## Report on Review of Bay Delta Conservation Program Modeling

Since December 2012, MBK Engineers and Dan Steiner (collectively “Reviewers”) have assisted various parties in evaluating the operations modeling that was performed for the Bay Delta Conservation Plan (BDCP). To assist in understanding BDCP and the potential implications, stakeholders<sup>1</sup> requested that the Reviewers review the CalSim II modeling studies performed as part of the BDCP (hereafter “BDCP Studies” or “BDCP Model”).

This Report summarizes: (1) the Reviewers’ independent analysis and review of the BDCP Model, publicly released for the BDCP’s Draft EIR/S in December 2013, (2) the Reviewers’ updates and corrections made to the BDCP Model, and (3) comparisons between the original BDCP Model and the independent Model as revised by the Reviewers.

Figure 1. Projected Inflow to Trinity, Shasta, Oroville, and Folsom Reservoirs – NAA, NAA-ELT and NAA-LLT

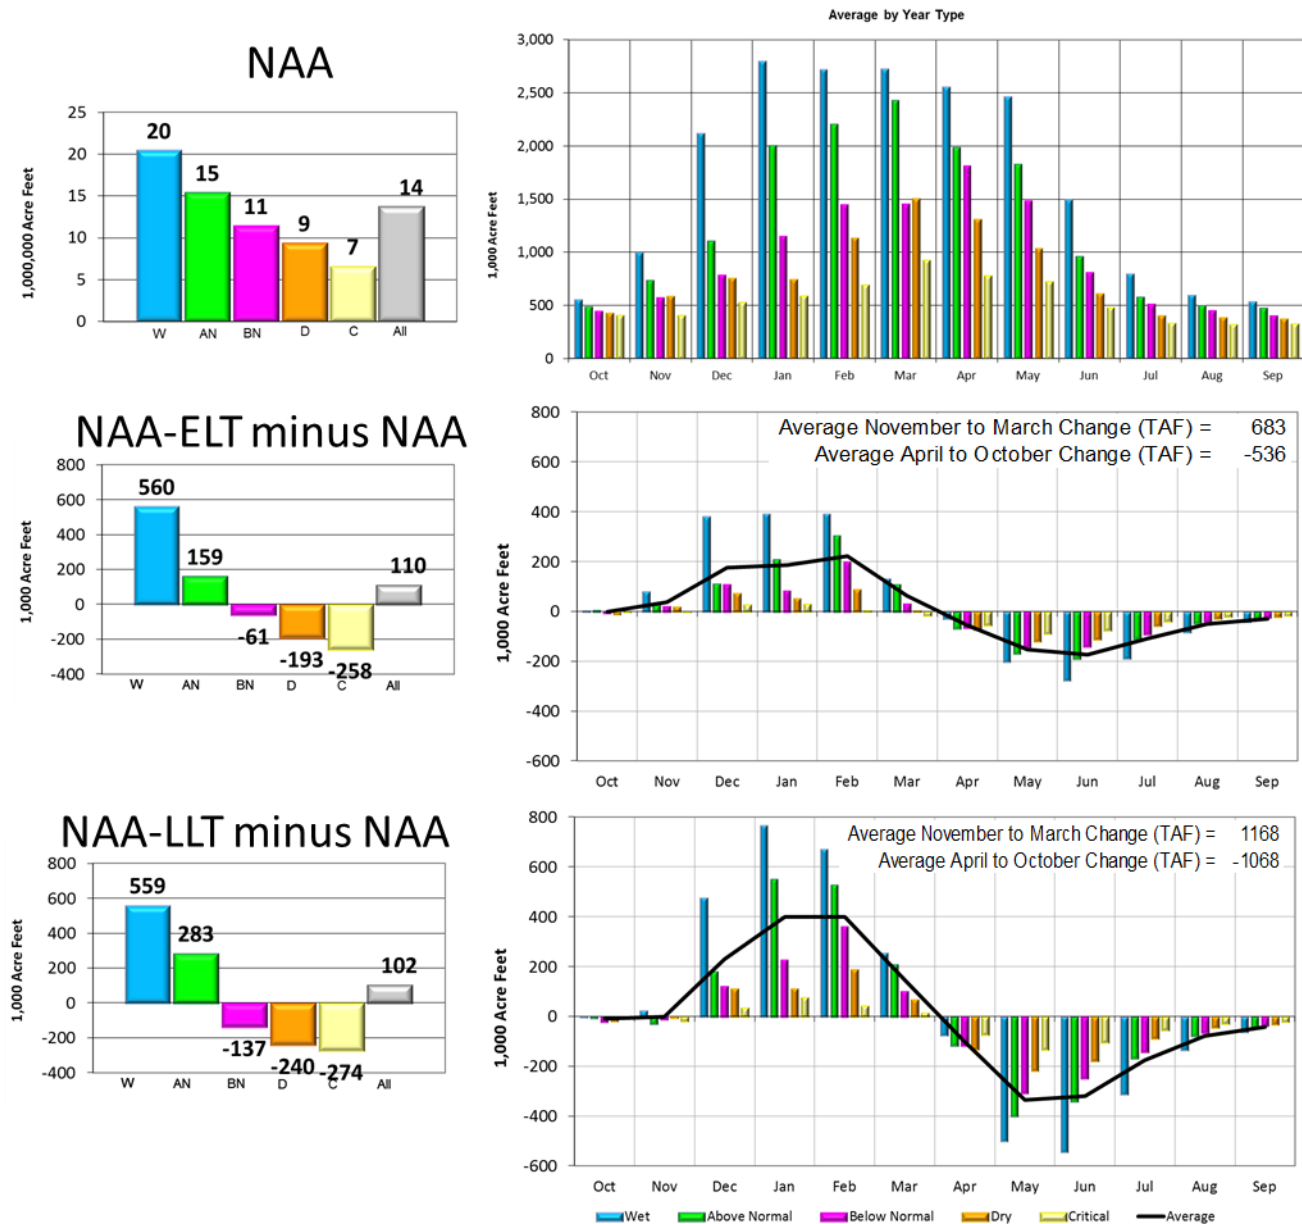
The significance of changed hydrology between the three without project baselines is illustrated in Figure 1 below. The figure illustrates the projected combined inflow of Trinity, Shasta, Oroville, and Folsom Reservoirs under the three NAA baselines. Numerous modeling projections for climate change have been developed, and in this BDCP group of Scenarios Trinity, Shasta, and Oroville inflow are projected to increase overall, but with a

In our opinion, the CalSim II depicted operations that incorporate climate change are not reasonably foreseeable and do not represent a likely future operation of the CVP/SWP. Although an argument is typically made that these study baselines will be used in a comparison analysis with Project Alternatives tiering from these baselines, we believe that the depicted operations do not represent credible CVP/SWP operations and we have no confidence in the results and they are inappropriate as the foundation of a Project Alternative. As such, although the modeling approach may provide a relative comparison between equal foundational operations, we are apprehensive to place much confidence in the computed differences shown between the NAA and Project Alternative Scenarios.

Figure 2. Projected Shasta Reservoir Carryover Storage, NAA, NAA-ELT and NAA-LLT

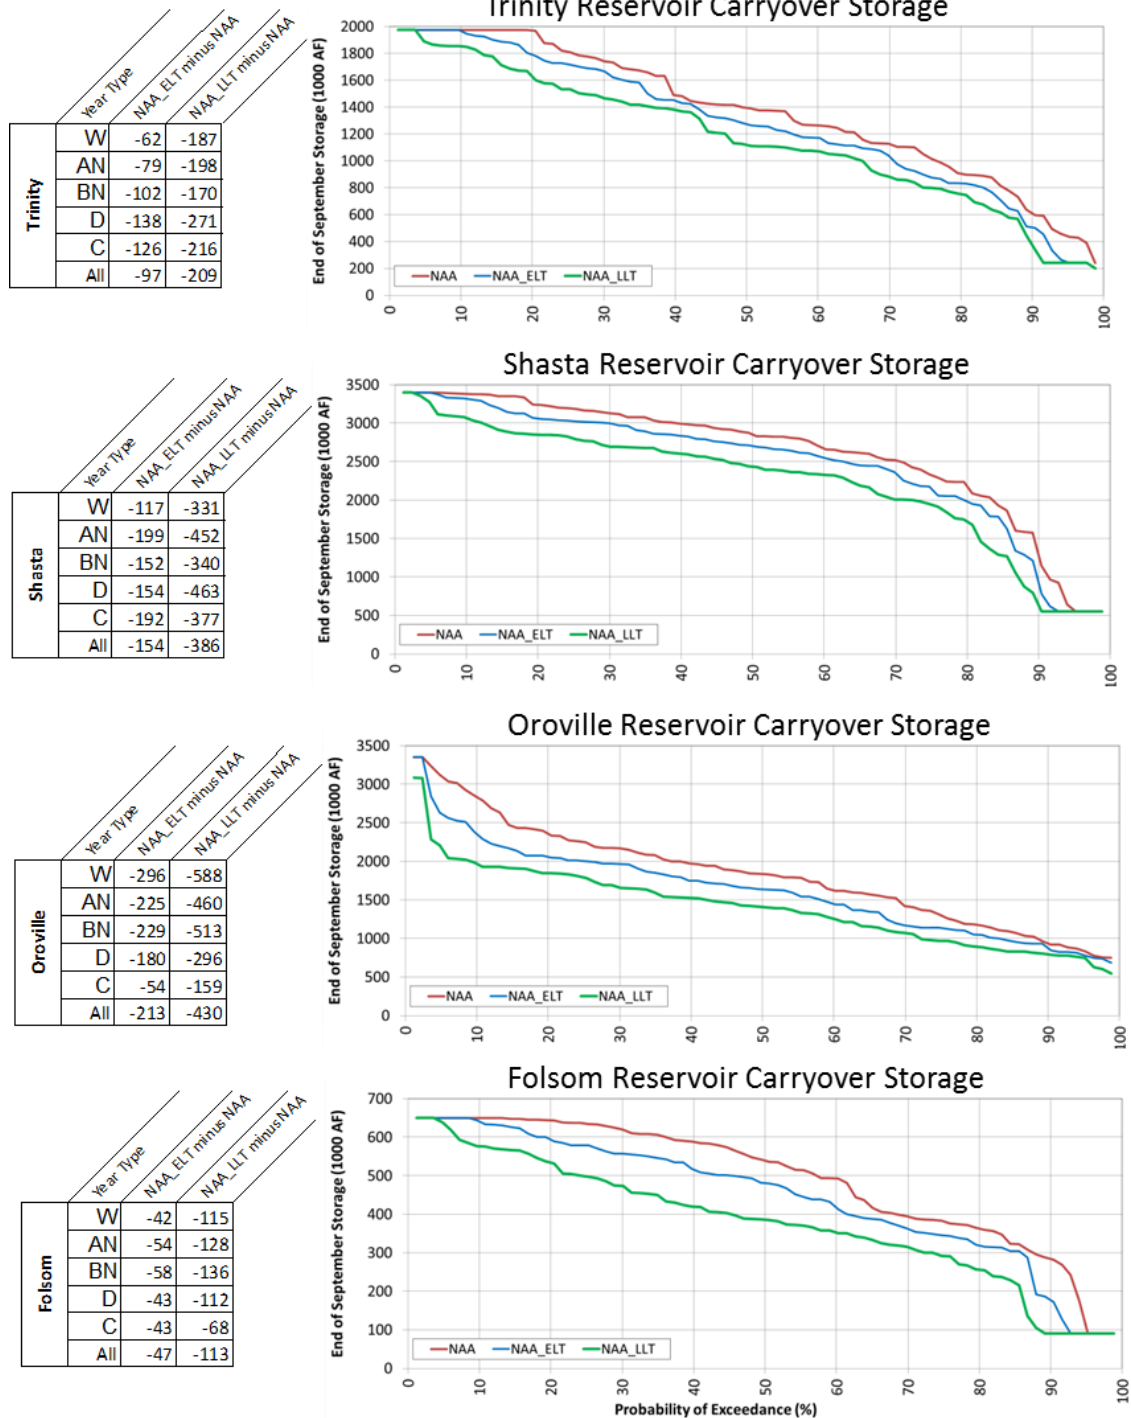
For upstream CVP and SWP reservoirs the assumed shift of inflows due to climate change (Figure 1) along with a continuing need to satisfy exports demands significantly affects carryover storage. The CVP and SWP simply cannot satisfy water demands and regulatory criteria imposed on them in the NAA-ELT and NAA-LLT modeling scenarios.

Figure 2 illustrates the typical change in carryover storage as shown for Trinity, Shasta, Oroville, and Folsom Reservoirs. The relatively high frequency (approximately 10% of time) of minimum storage occurring at CVP reservoirs illustrates our questioning of credible operations in the studies.

**Figure 3. Projected Inflow to Millerton Lake –NAA, NAA-ELT and NAA-LLT**

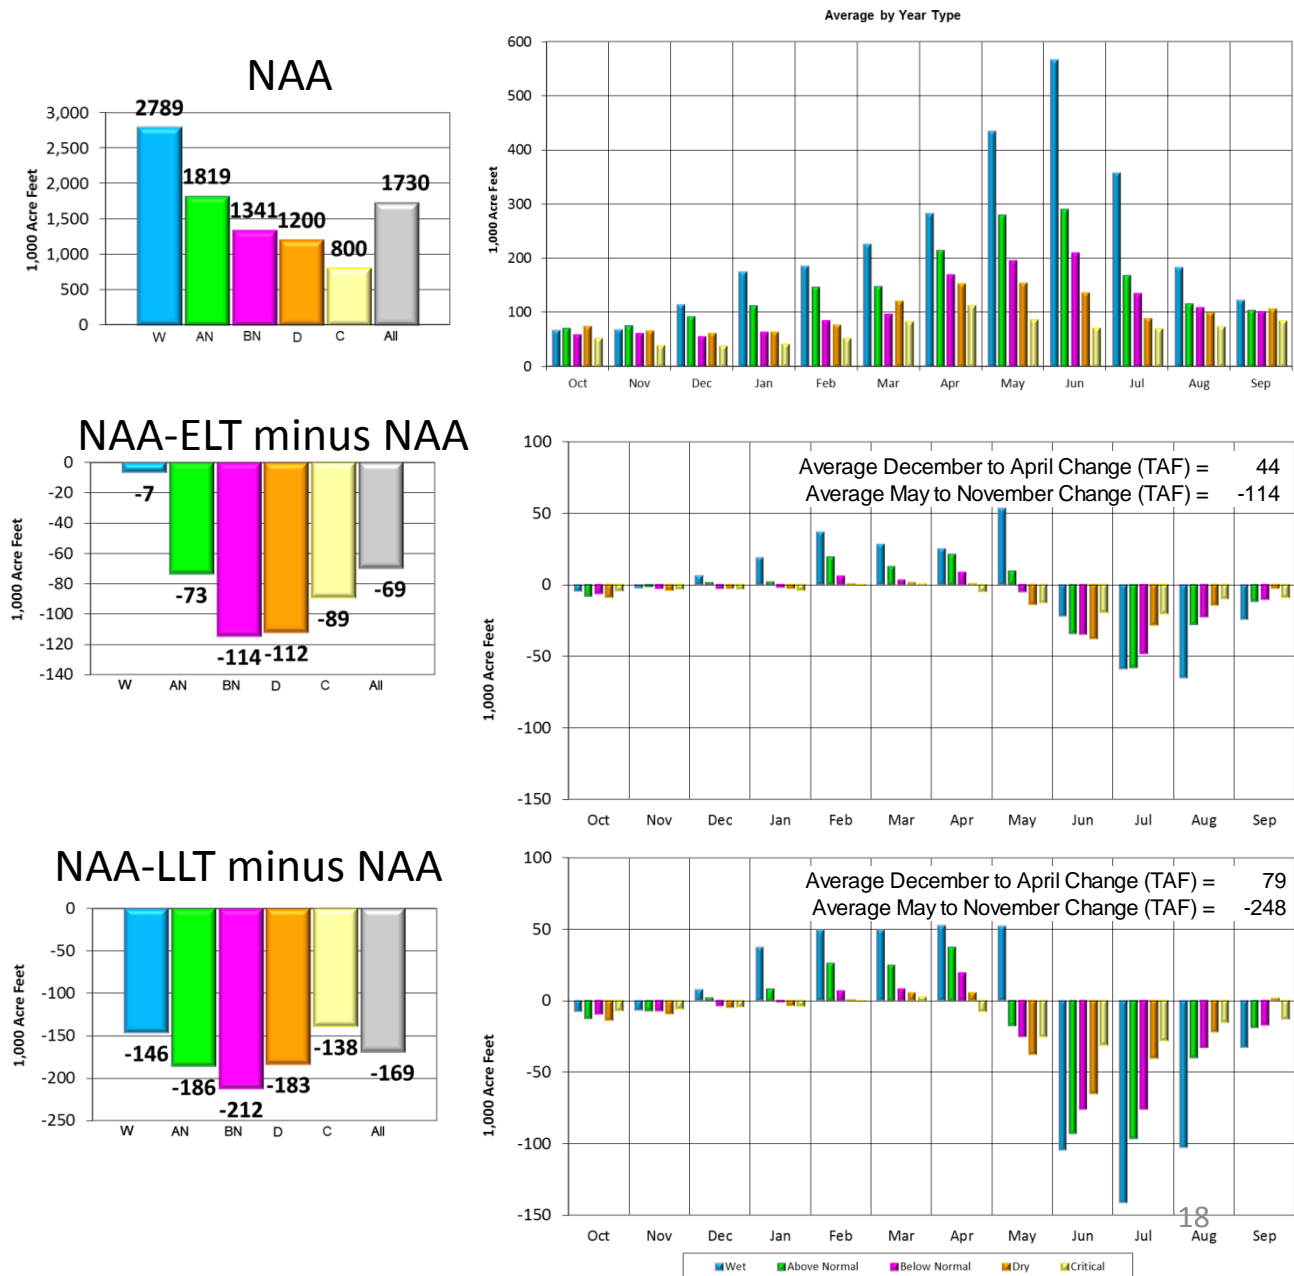
San Joaquin Valley reservoirs are depicted with an overall decrease in annual runoff with some shifting of runoff from spring to winter, but mostly just decreases in spring runoff due to a decline in snowmelt runoff during late spring<sup>5</sup>. Figure 3 illustrates the assumed effects of climate change upon inflow to Millerton Lake.

The hydrology differences imposed in the NAA Scenarios of the Friant Division are described above, and its appropriateness may be subject to additional debate and Alternative assumptions. However, our review found that implementation of Millerton Reservoir inflow as affected by climate change was improperly performed.

**Figure 4. Millerton Reservoir Carryover Storage, NAA, NAA-ELT and NAA-LLT Scenarios**

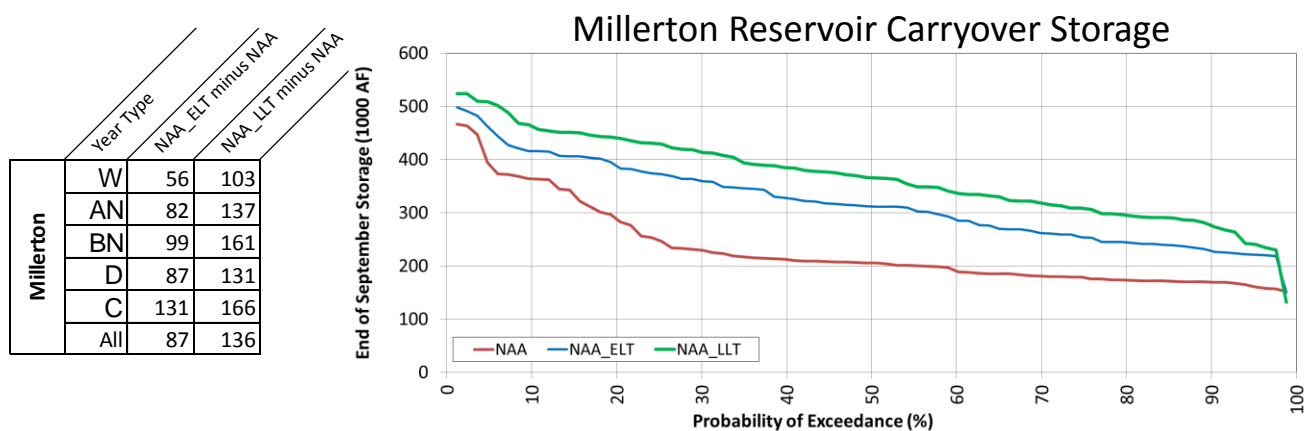
Inflow to Millerton Reservoir in this version of CalSim is input in three separate time series for purposes of depicting the hydrology of potential upper basin reservoirs. Climate change hydrology was inconsistently incorporated at Millerton Reservoir and misapplied to the water supply and flood control operations. The result is an unrealistic operation for river releases and canal diversions. Figure 3 illustrates the projected ELT and LLT changes in Millerton Reservoir inflow incorporated in these studies. On face value of the input data, regardless of Friant Dam river release assumptions the effect of climate change at Millerton Lake will affect water deliveries.

Evidence of the inconsistent inflow problem is shown in the result for the comparison of carryover storage of Millerton Reservoir under the NAA, NAA-ELT, and NAA-LLT Scenarios (Figure 4). Carryover storage is higher in the ELT and LLT Scenarios due to climate change effects to inflow incorporated in reservoir operations but not in the computation of water supply deliveries. Thus, water deliveries are suppressed and the reservoir ends the year with greater storage.

**Figure 12. Temperature Exceedance Sacramento River at Bend Bridge Existing, No Action Alternative, ELT**

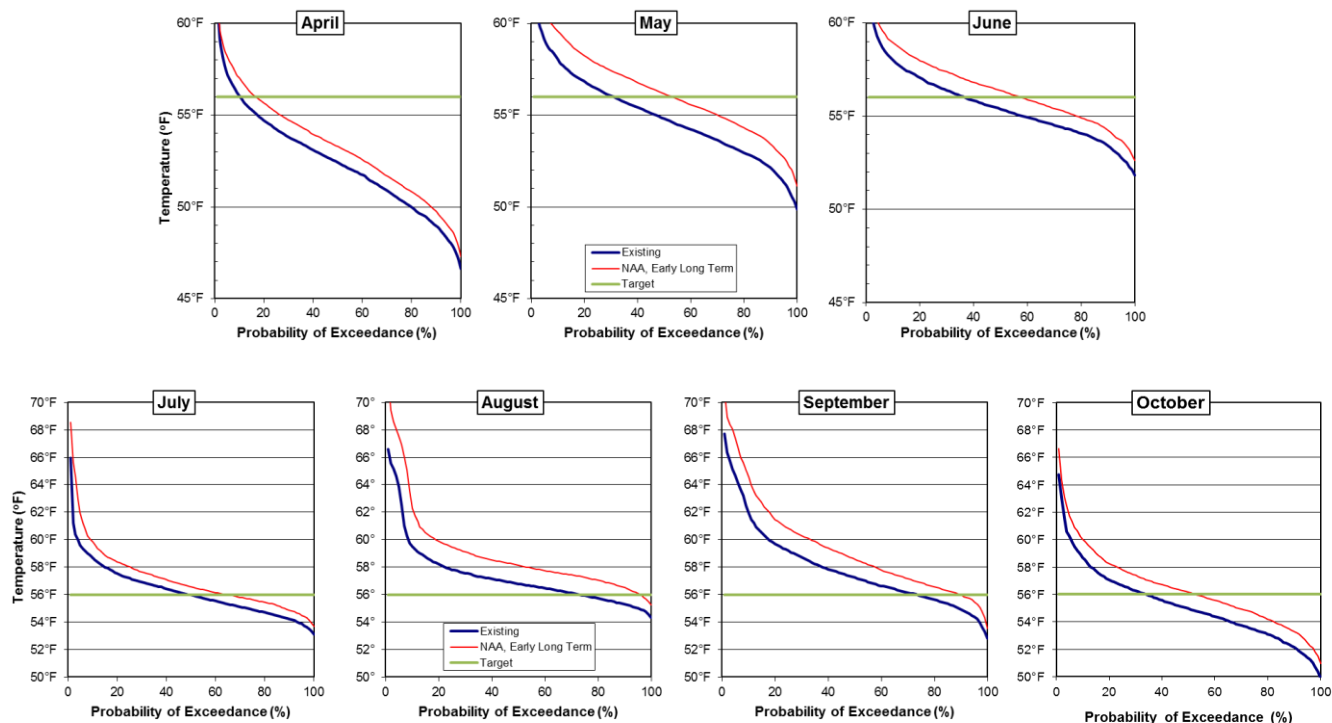
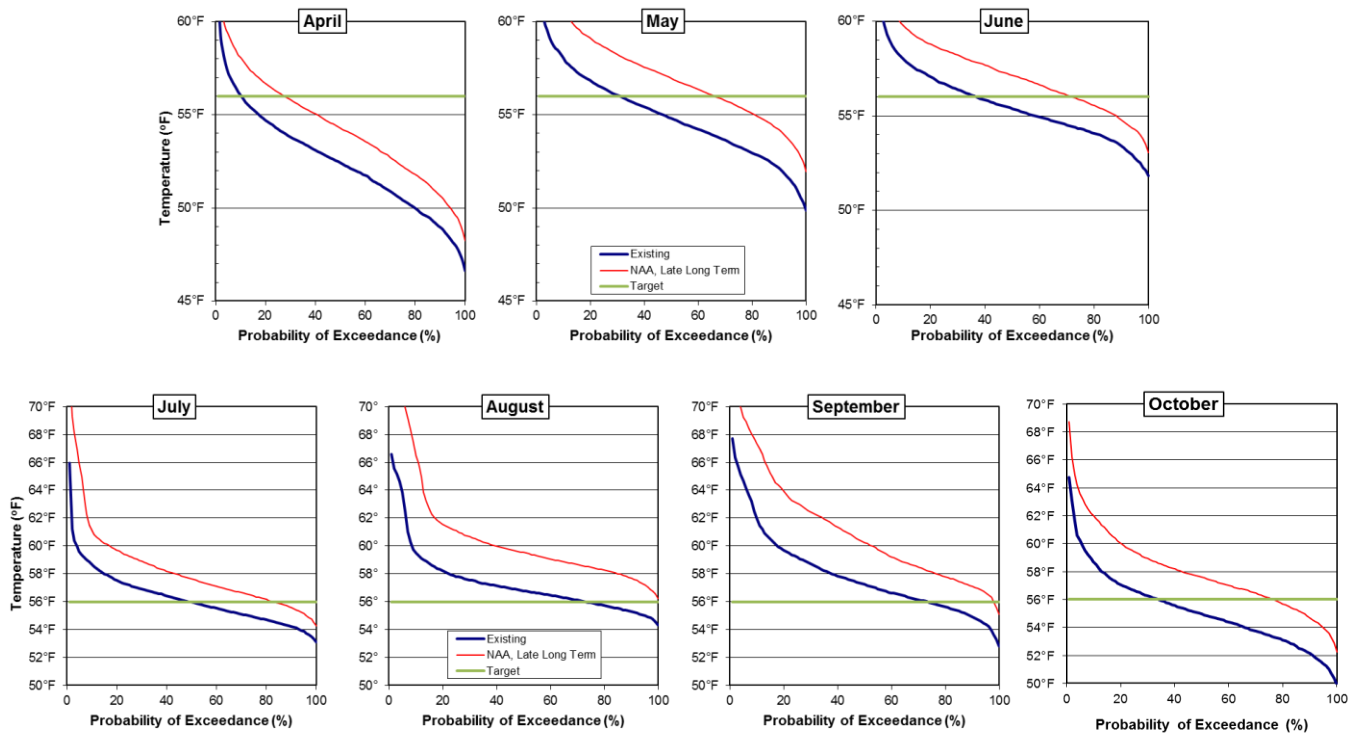
The increase in equilibrium temperatures combined with decreases in storage would lead to water temperature conditions that would likely not achieve the assumed objectives. Figure 12 and Figure 13 illustrate an increase in the probability that a water temperature target of 56°F would be exceeded at Bend Bridge under both the NAA-ELT and NAA-LLT Scenarios. The probability of exceedance increases approximately 5% to 20% depending on the month for the NAA-ELT Scenario and approximately 10% to 40% for the NAA-LLT Scenario.

**Figure 19. NDD, Bypass Requirement, Bypass Flow, and Excess Sacramento R. flow for Alt 4-ELT**

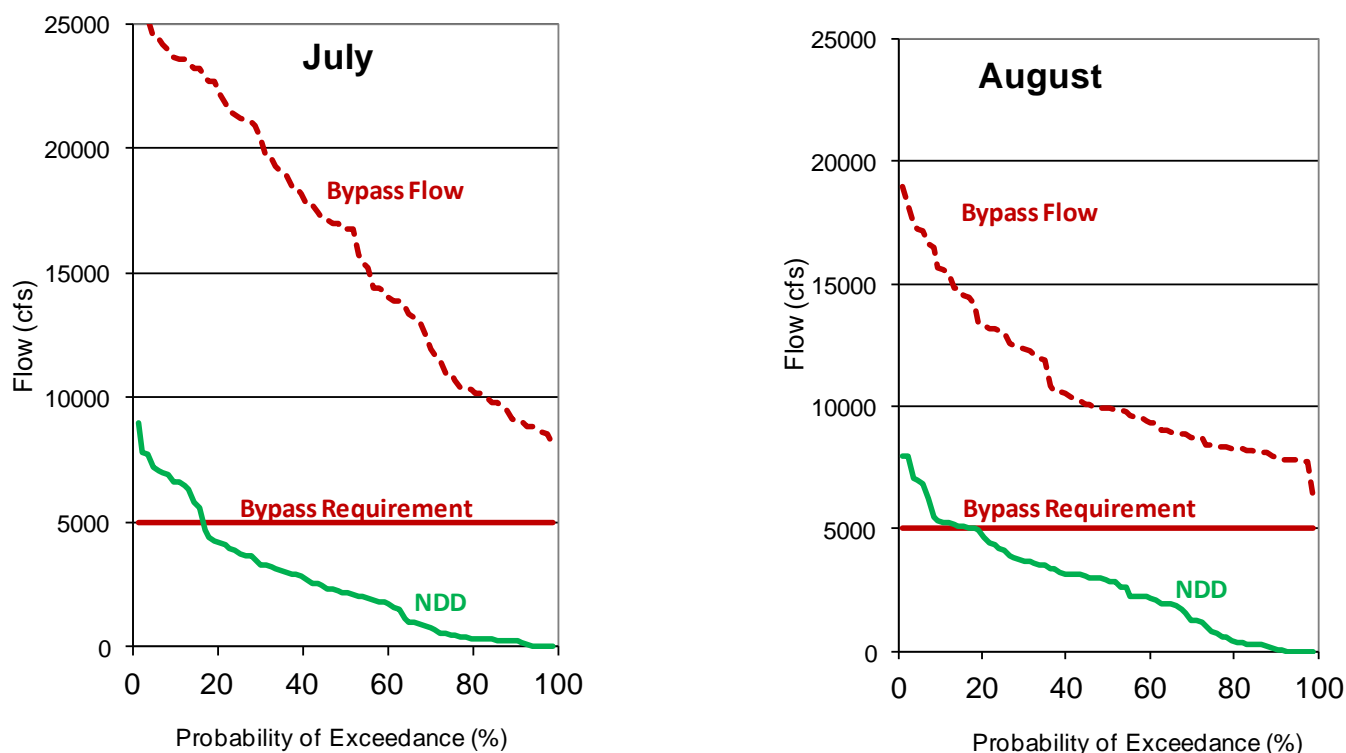
Sacramento River flow below the North Delta Diversion (NDD) must be maintained above the specified bypass flow requirement, therefore the NDD rates are limited to the Sacramento River flow above the bypass requirement. Due to an error in CalSim II that specifies an unintended additional bypass requirement, modeling performed for the BDCP EIRS often bypasses more Sacramento River flow than is specified in the BDCP project description. This error has been fixed in the most recent public releases of CalSim II, but BDCP modeling has not been updated to reflect these fixes. Figure 19 contains exceedance probability plots showing the Sacramento River required bypass, Sacramento River bypass flow, NDD, and excess Sacramento River flow to the Delta as modeling for BDCP. As can be seen in Figure 19, the bypass flow is always above the bypass requirement in July and August. The BDCP version of CalSim sets a requirement for Sacramento River inflow to the Delta needed to satisfy all Delta flow, quality, and export requirements, this requirement should be removed when modeling the NDD.
